O0120-013A-13
June 10, 2021

Re: **Village at Grafton Woods, 8 Pine Street
Plan Approval Application - Peer Review Response to Comments 2**

C-105

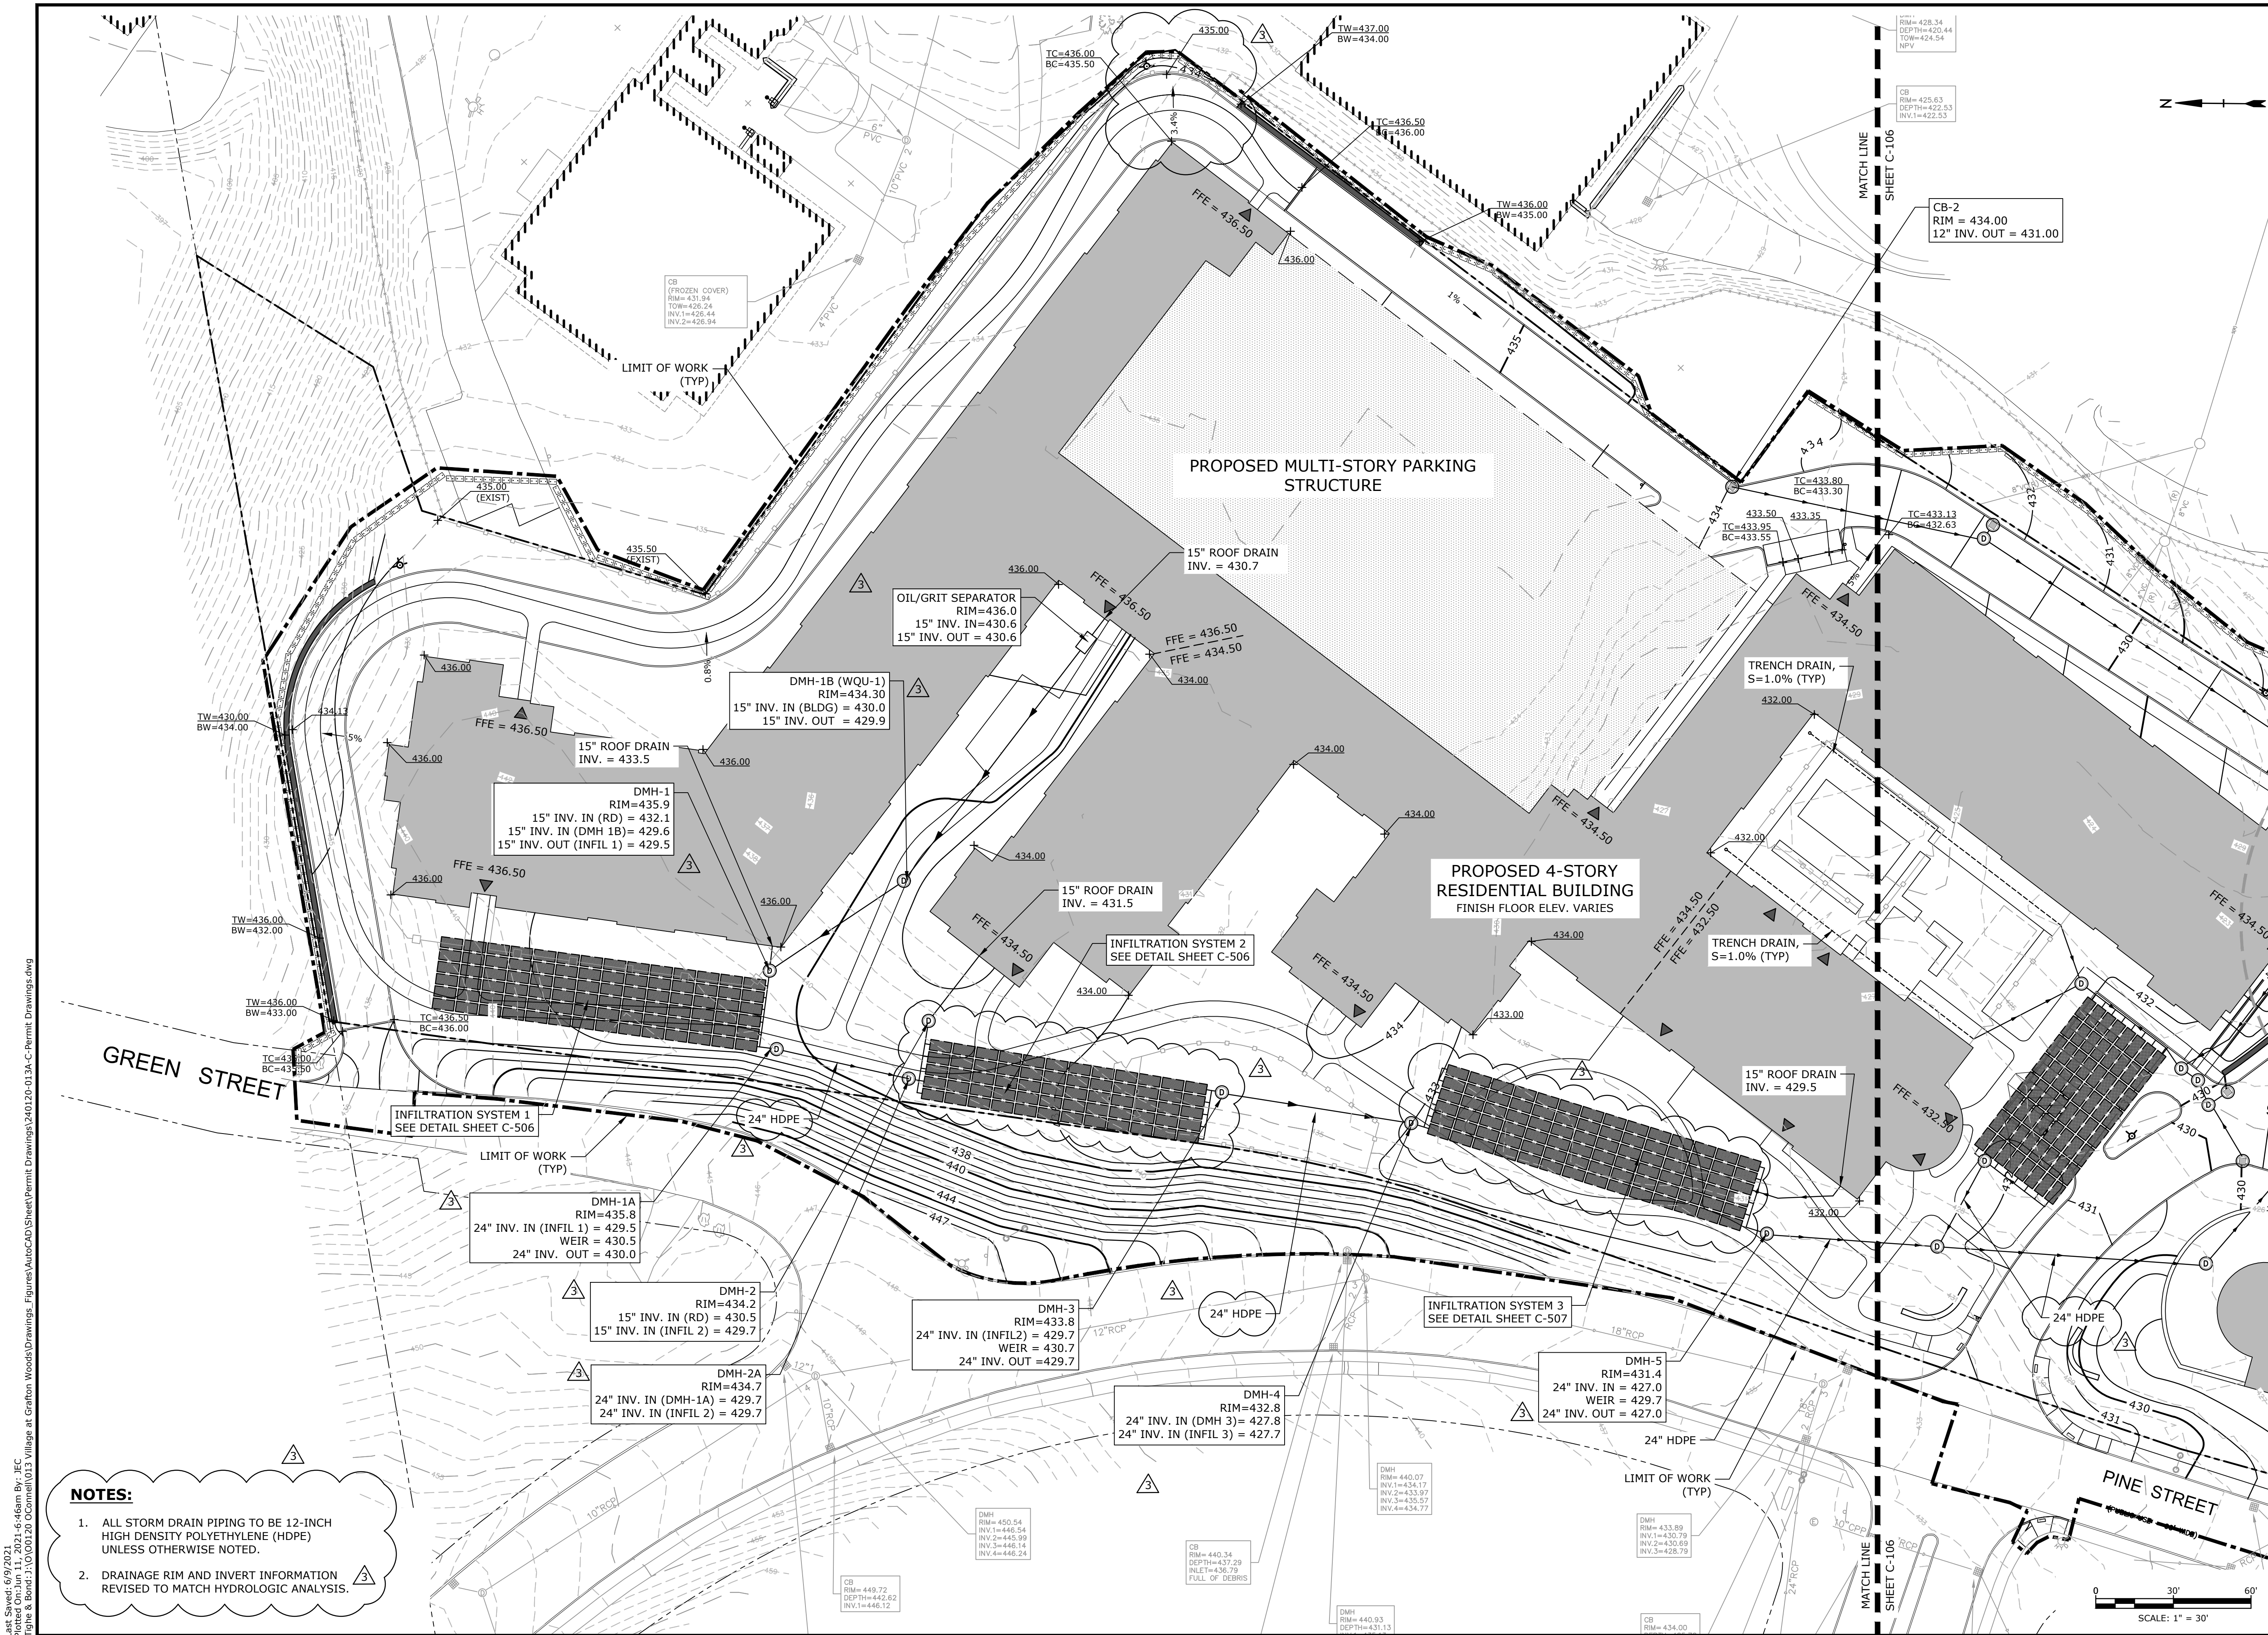
30. Sheet C-106 has erosion control barriers only proximate to the wetlands. Erosion control barriers need to be provided at all down-gradient sides of the work on Sheet C-105 and C-106.

GEI Response 6/3/21: GEI could not find symbols or lines for the proposed erosion control barriers on Sheets C-105 and C-106. It appears that the AutoCAD layer for erosion control barriers was accidentally turned off.

T&B Response 6/10/21: Linework in the AutoCAD file did not appear properly when the sheets were printed. Revised plan sheets C-105 and C-106 are attached showing erosion and sedimentation control barriers along the limit of work.

C-507

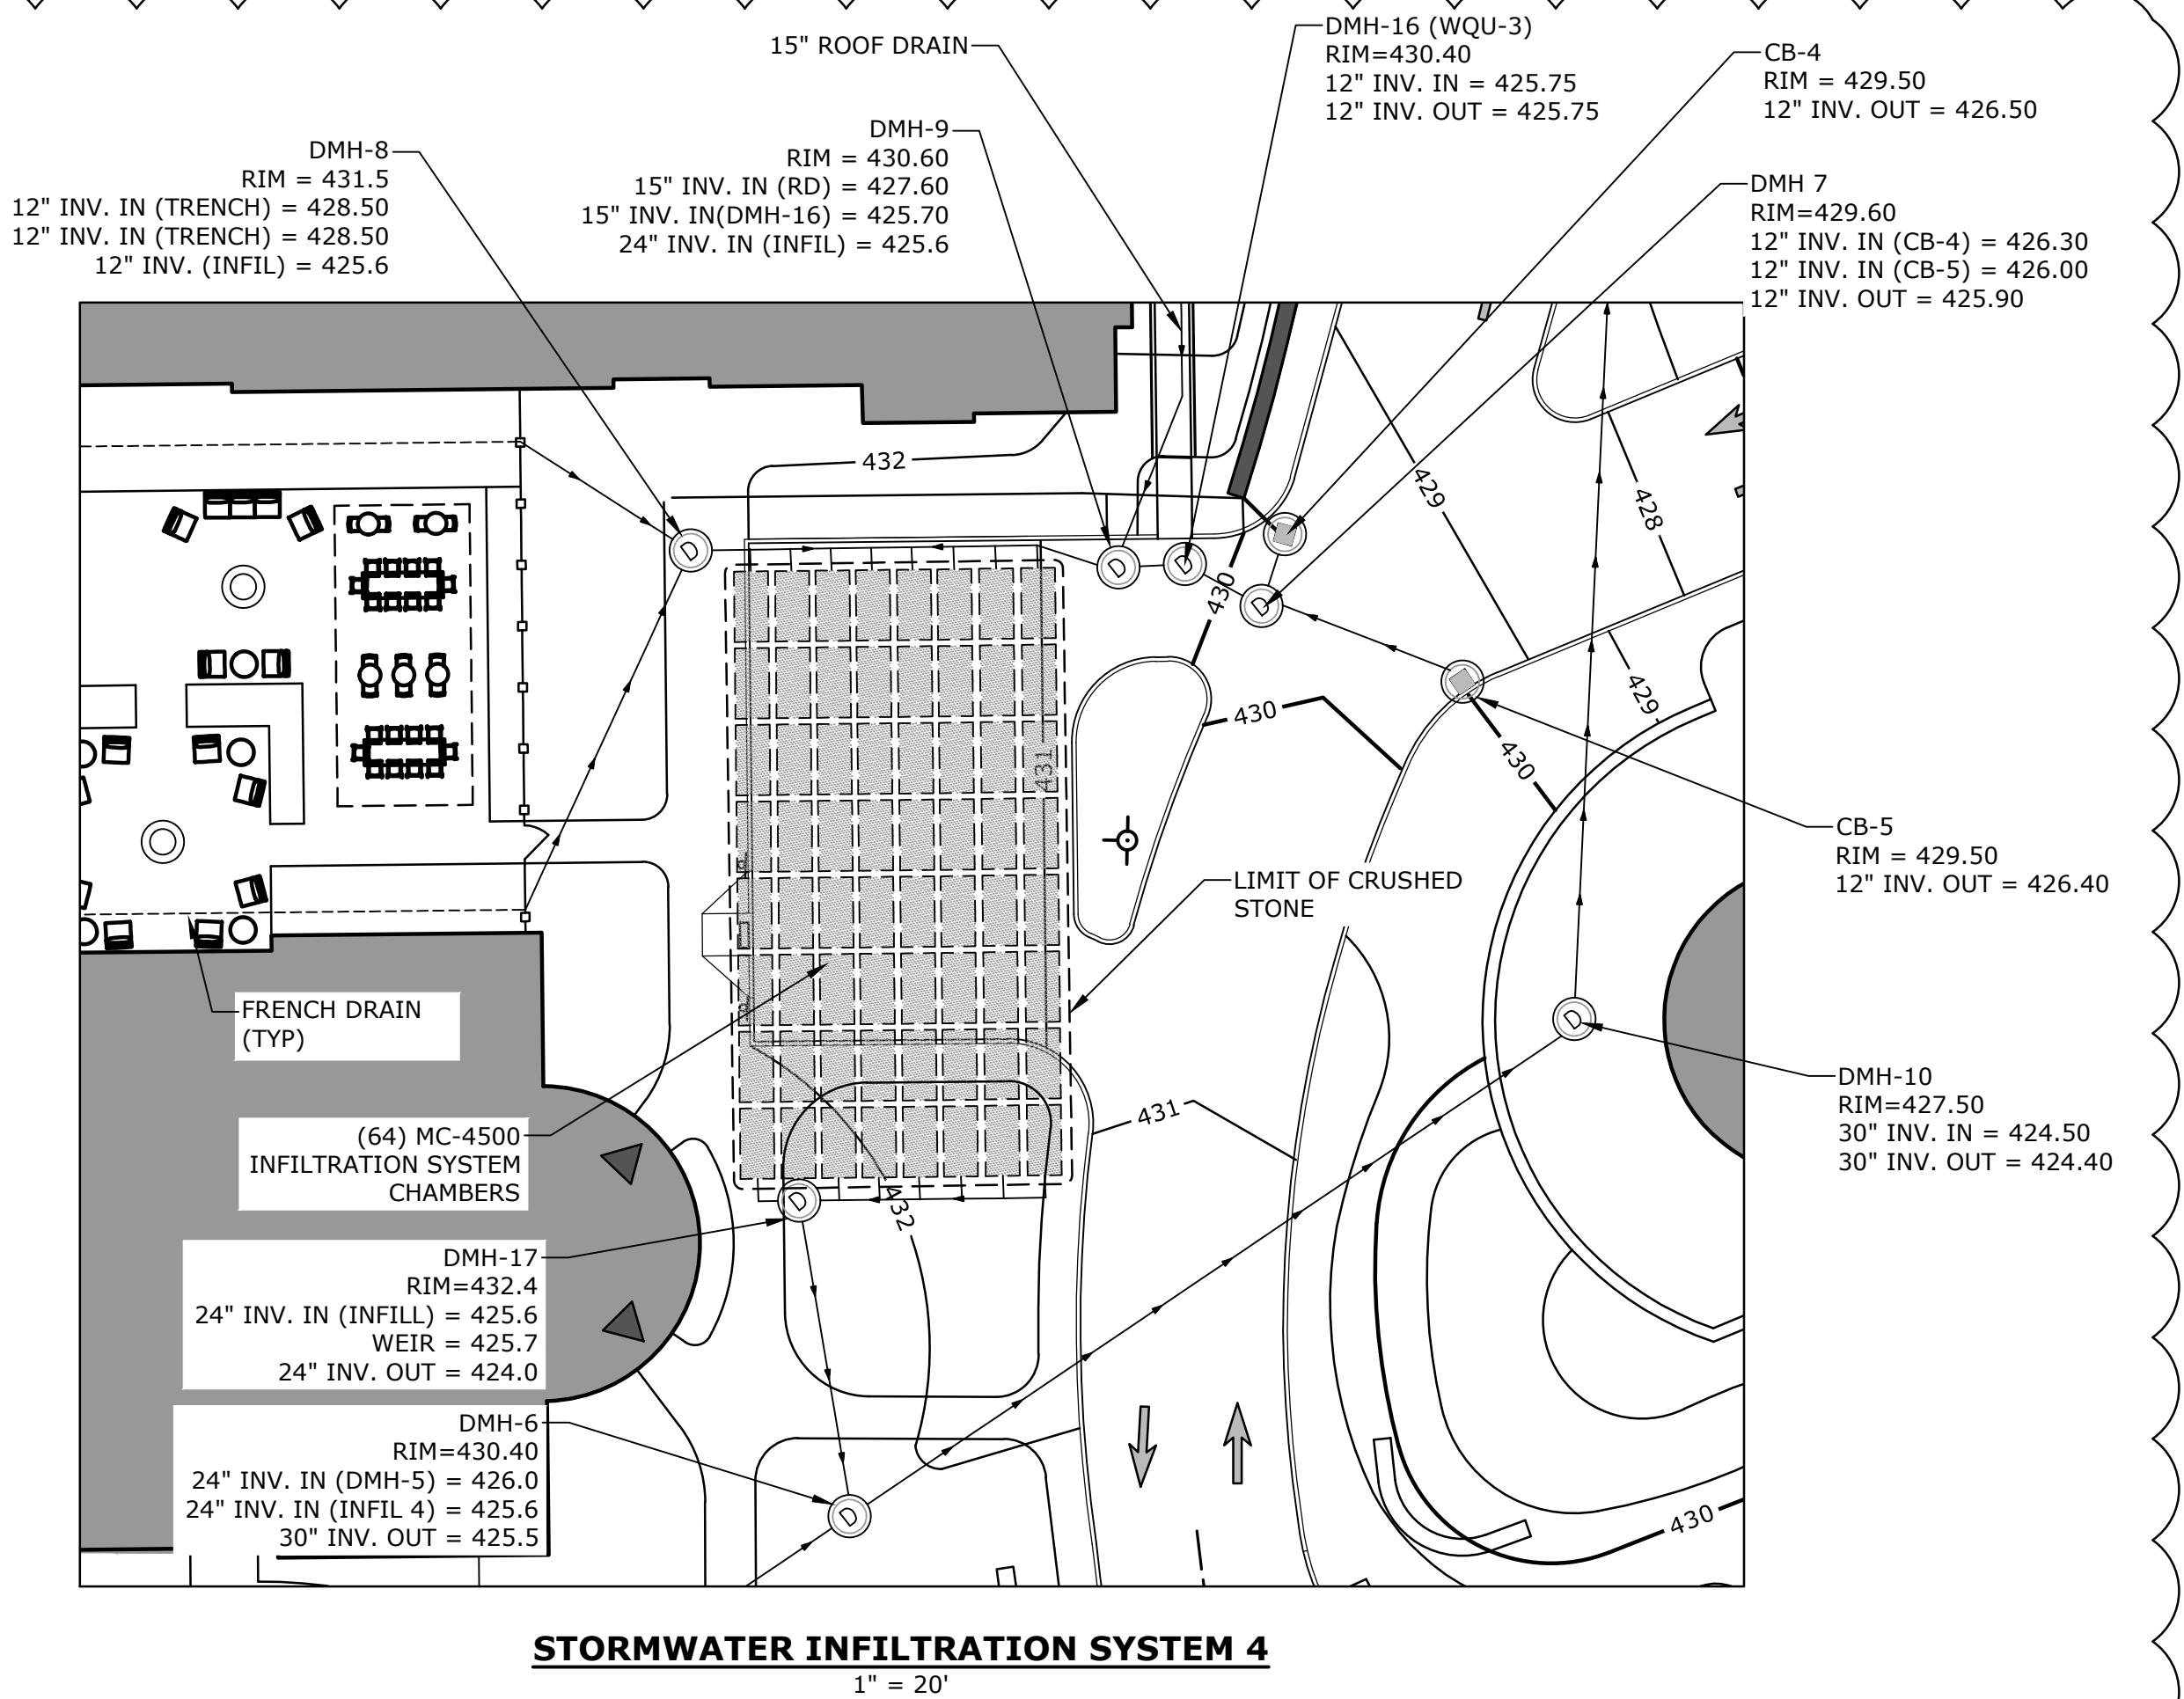
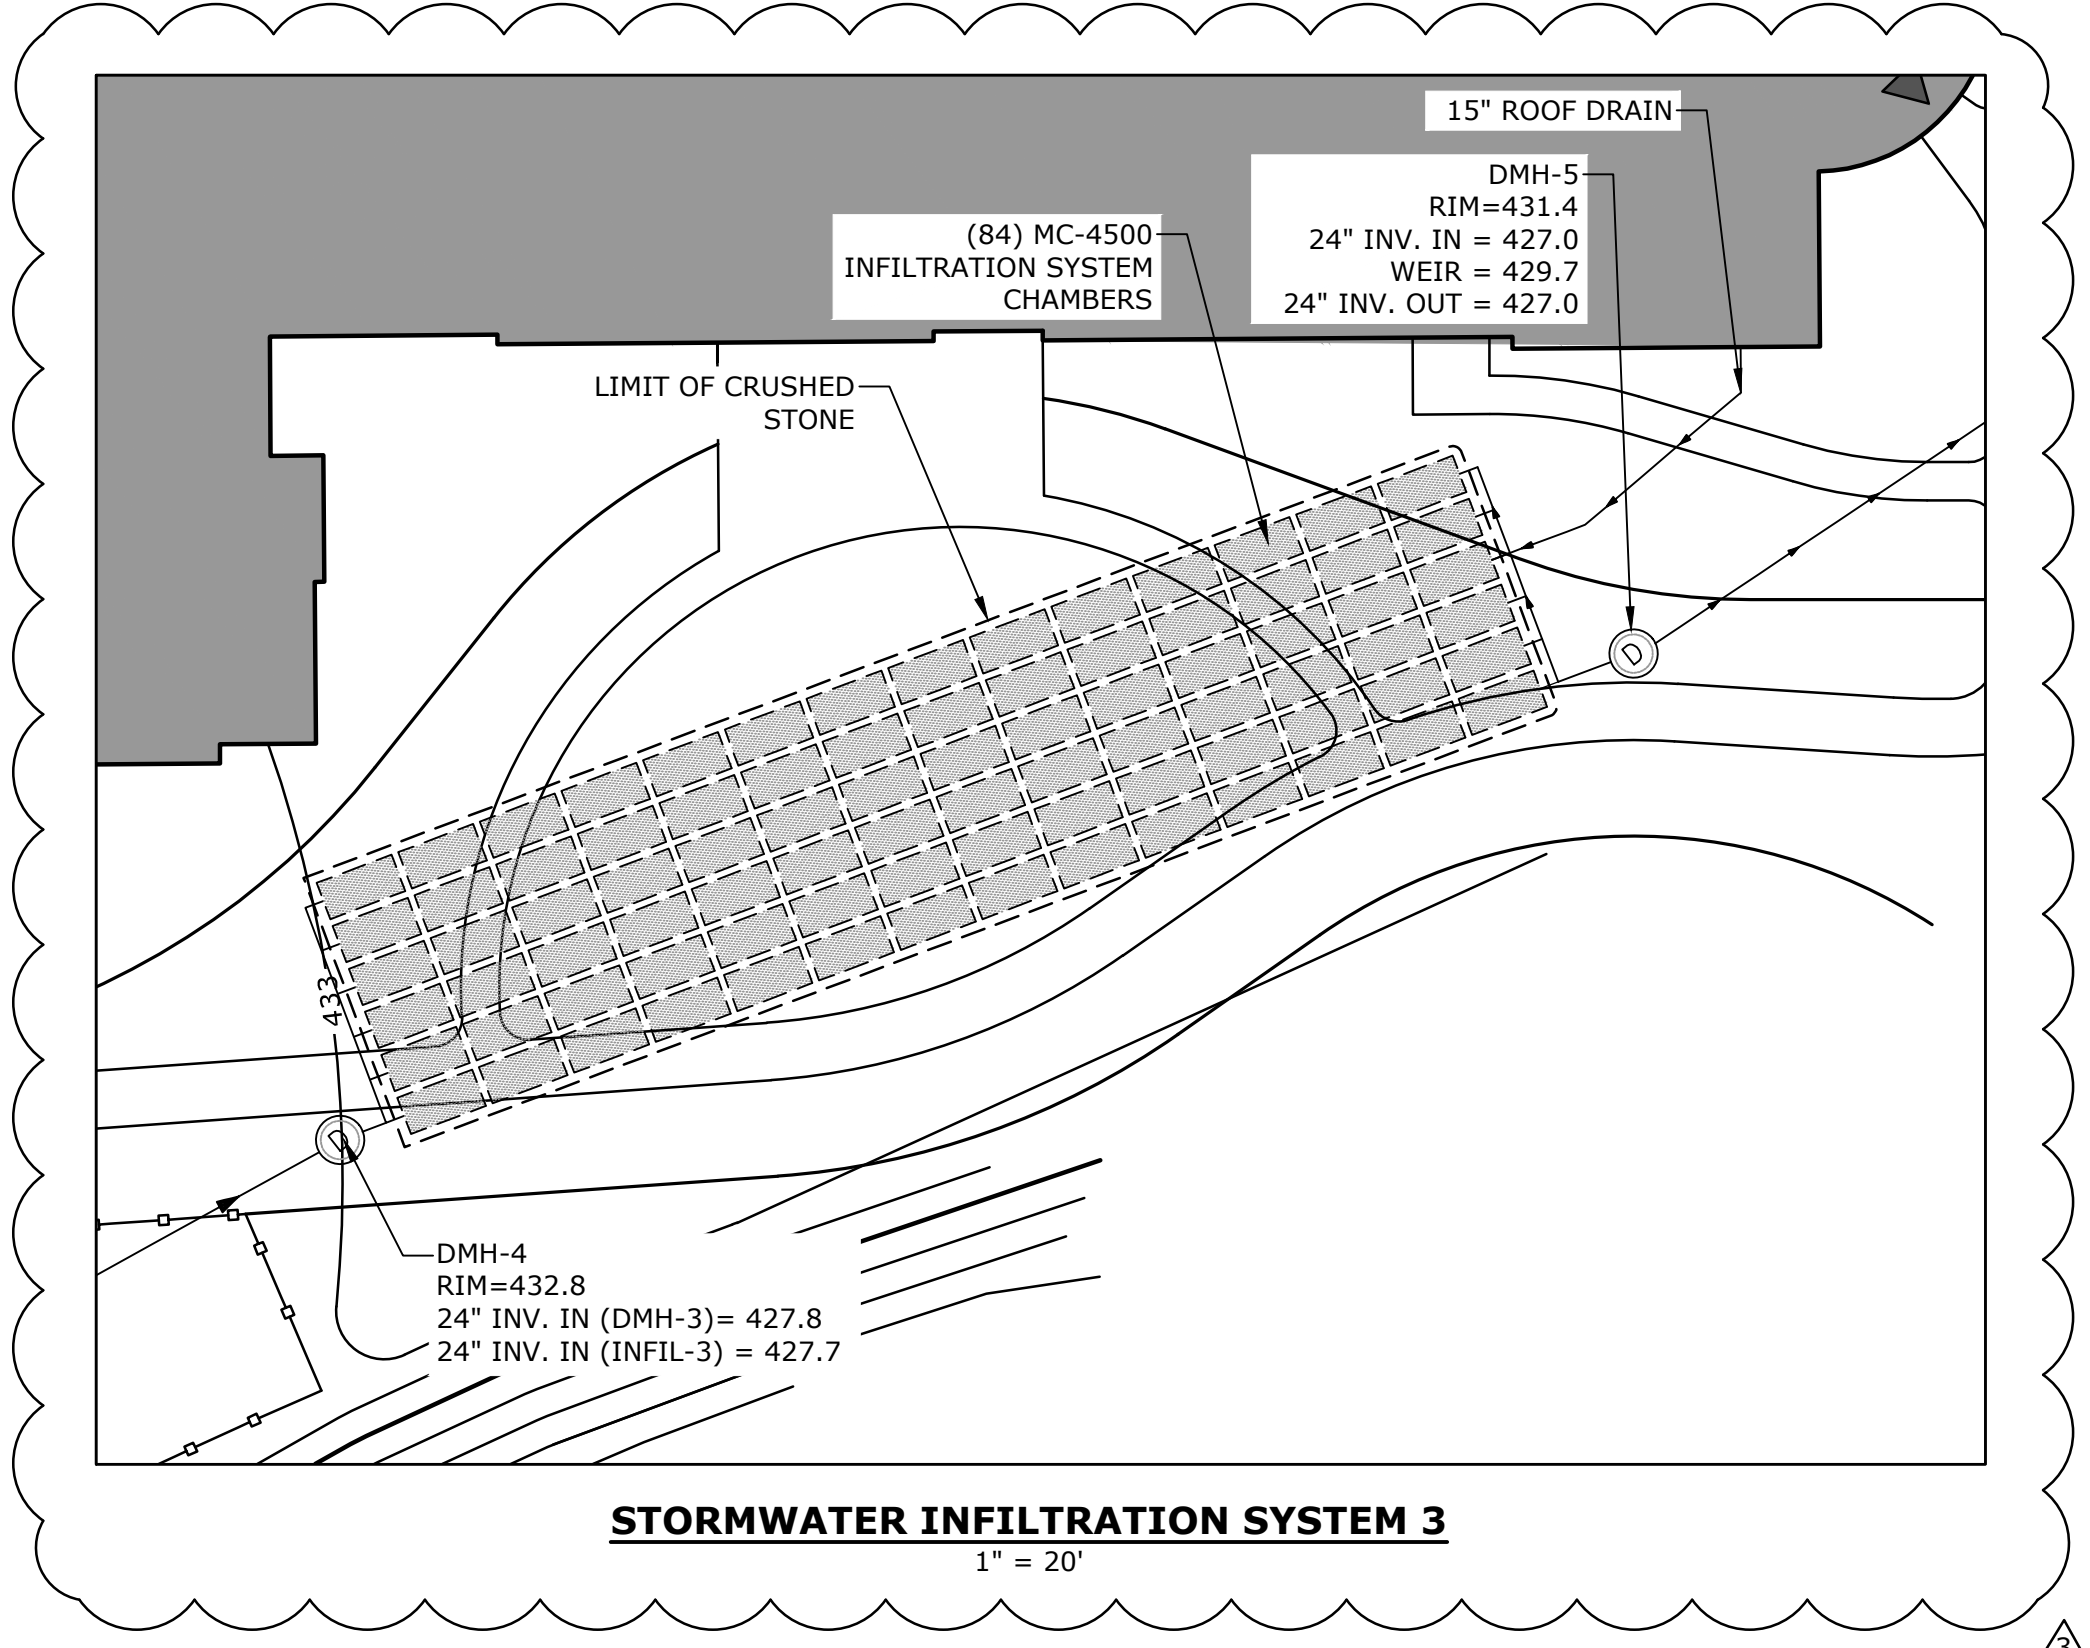
38. Pertinent elevations (e.g. bottom of stone, bottom of chambers) need to be provided on the plans for the subsurface infiltration systems.

T&B Response 6/10/21: Revised detail sheet C-507 has been revised to include pertinent design elevation data for each subsurface infiltration system. Detail sheets are attached to this letter.
